# Change Order No.1

Project: **Kirsi Circle Water Main Replacement Project**

**Change Order No. 1**  
**Description and Reason for Change**

**SIDEWALK AND BERM LAYOUT**  
 SCALE: 1" = 15'

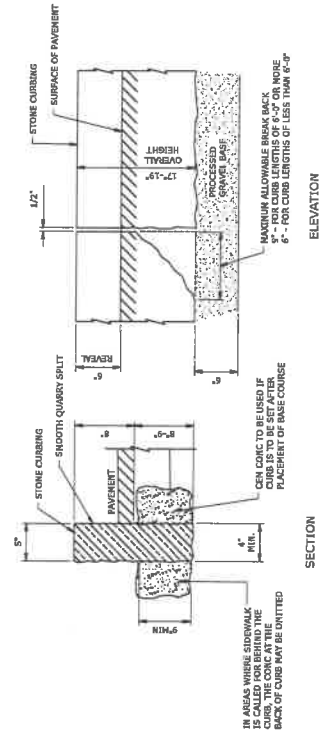
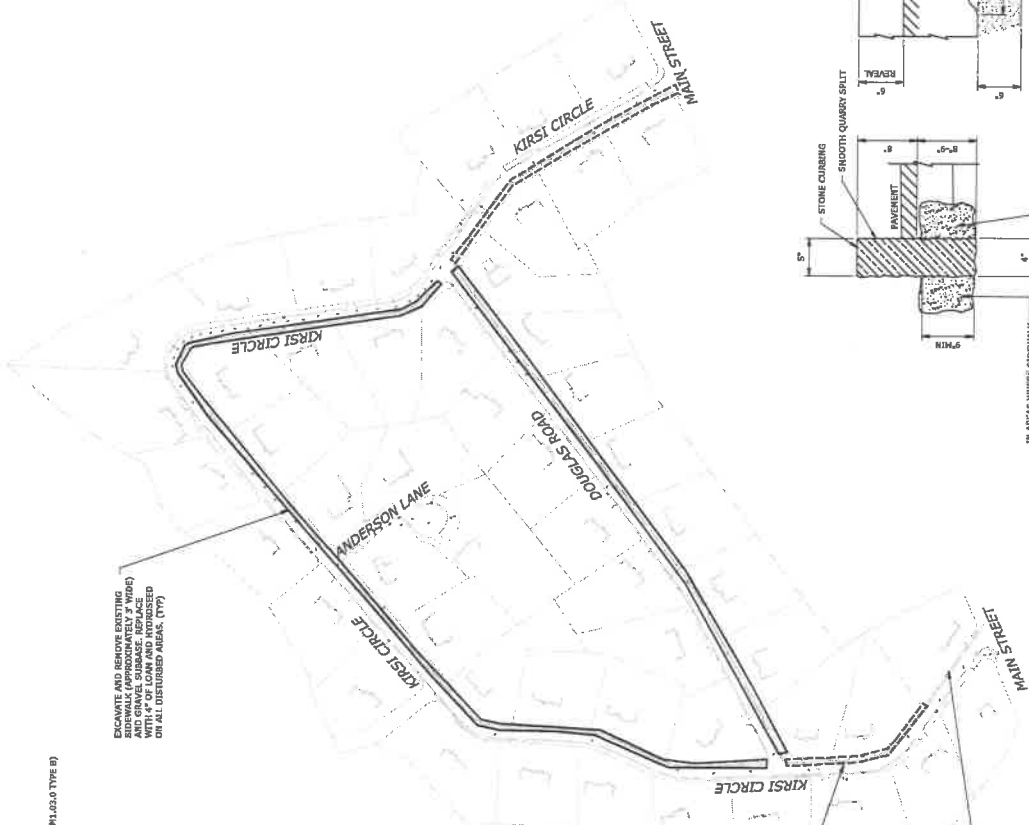
**Sawcut and remove paved sidewalk on Kirsi Circle and Douglas Road –** The Town of Westford and Tighe & Bond determined that the condition of the existing paved sidewalk on these streets is mostly in disrepair. The sidewalk is mostly not used by the residents of the neighborhood and they supported the removal. The Town is requesting that Joseph P. Cardillo & Son, Inc. remove all existing paved sidewalks on Kirsi Circle north of Douglas Road, and all sidewalks on Douglas Road and all disturbed areas will be replaced with screened loam and hydroseeded.

**Sawcut paved sidewalk on Kirsi Circle and prepare area for installation of granite curbing and new sidewalk by others –** The Town of Westford will utilize its existing agreement with Newport Materials to install new granite curbing and paved sidewalks on both ends of Kirsi Circle from Main Street to Douglas Road. The Town is requesting that Joseph P. Cardillo & Son saw cut the pavement based on the layout provided by the Town, remove the existing sidewalk, fine grade areas, install gravel subbase and compact for construction of sidewalk by Newport Materials. Once sidewalk construction is completed, Joseph P. Cardillo & Son will install additional loam and seed on any remaining disturbed areas as required.

EXCAVATE AND REMOVE EXISTING SIDEWALK (APPROXIMATELY 2' WIDE) AND DRIVEWAY (APPROXIMATELY 4' WIDE) WITH 4" OF LOAM AND INTRODUCED ON ALL DISTURBED AREAS. (TYP)

PREP FOR BITUMINOUS SIDEWALK AND GRANITE CURB PER DETAILS (TYP)

NEW EXISTING SIDEWALK NOT TO BE REMOVED
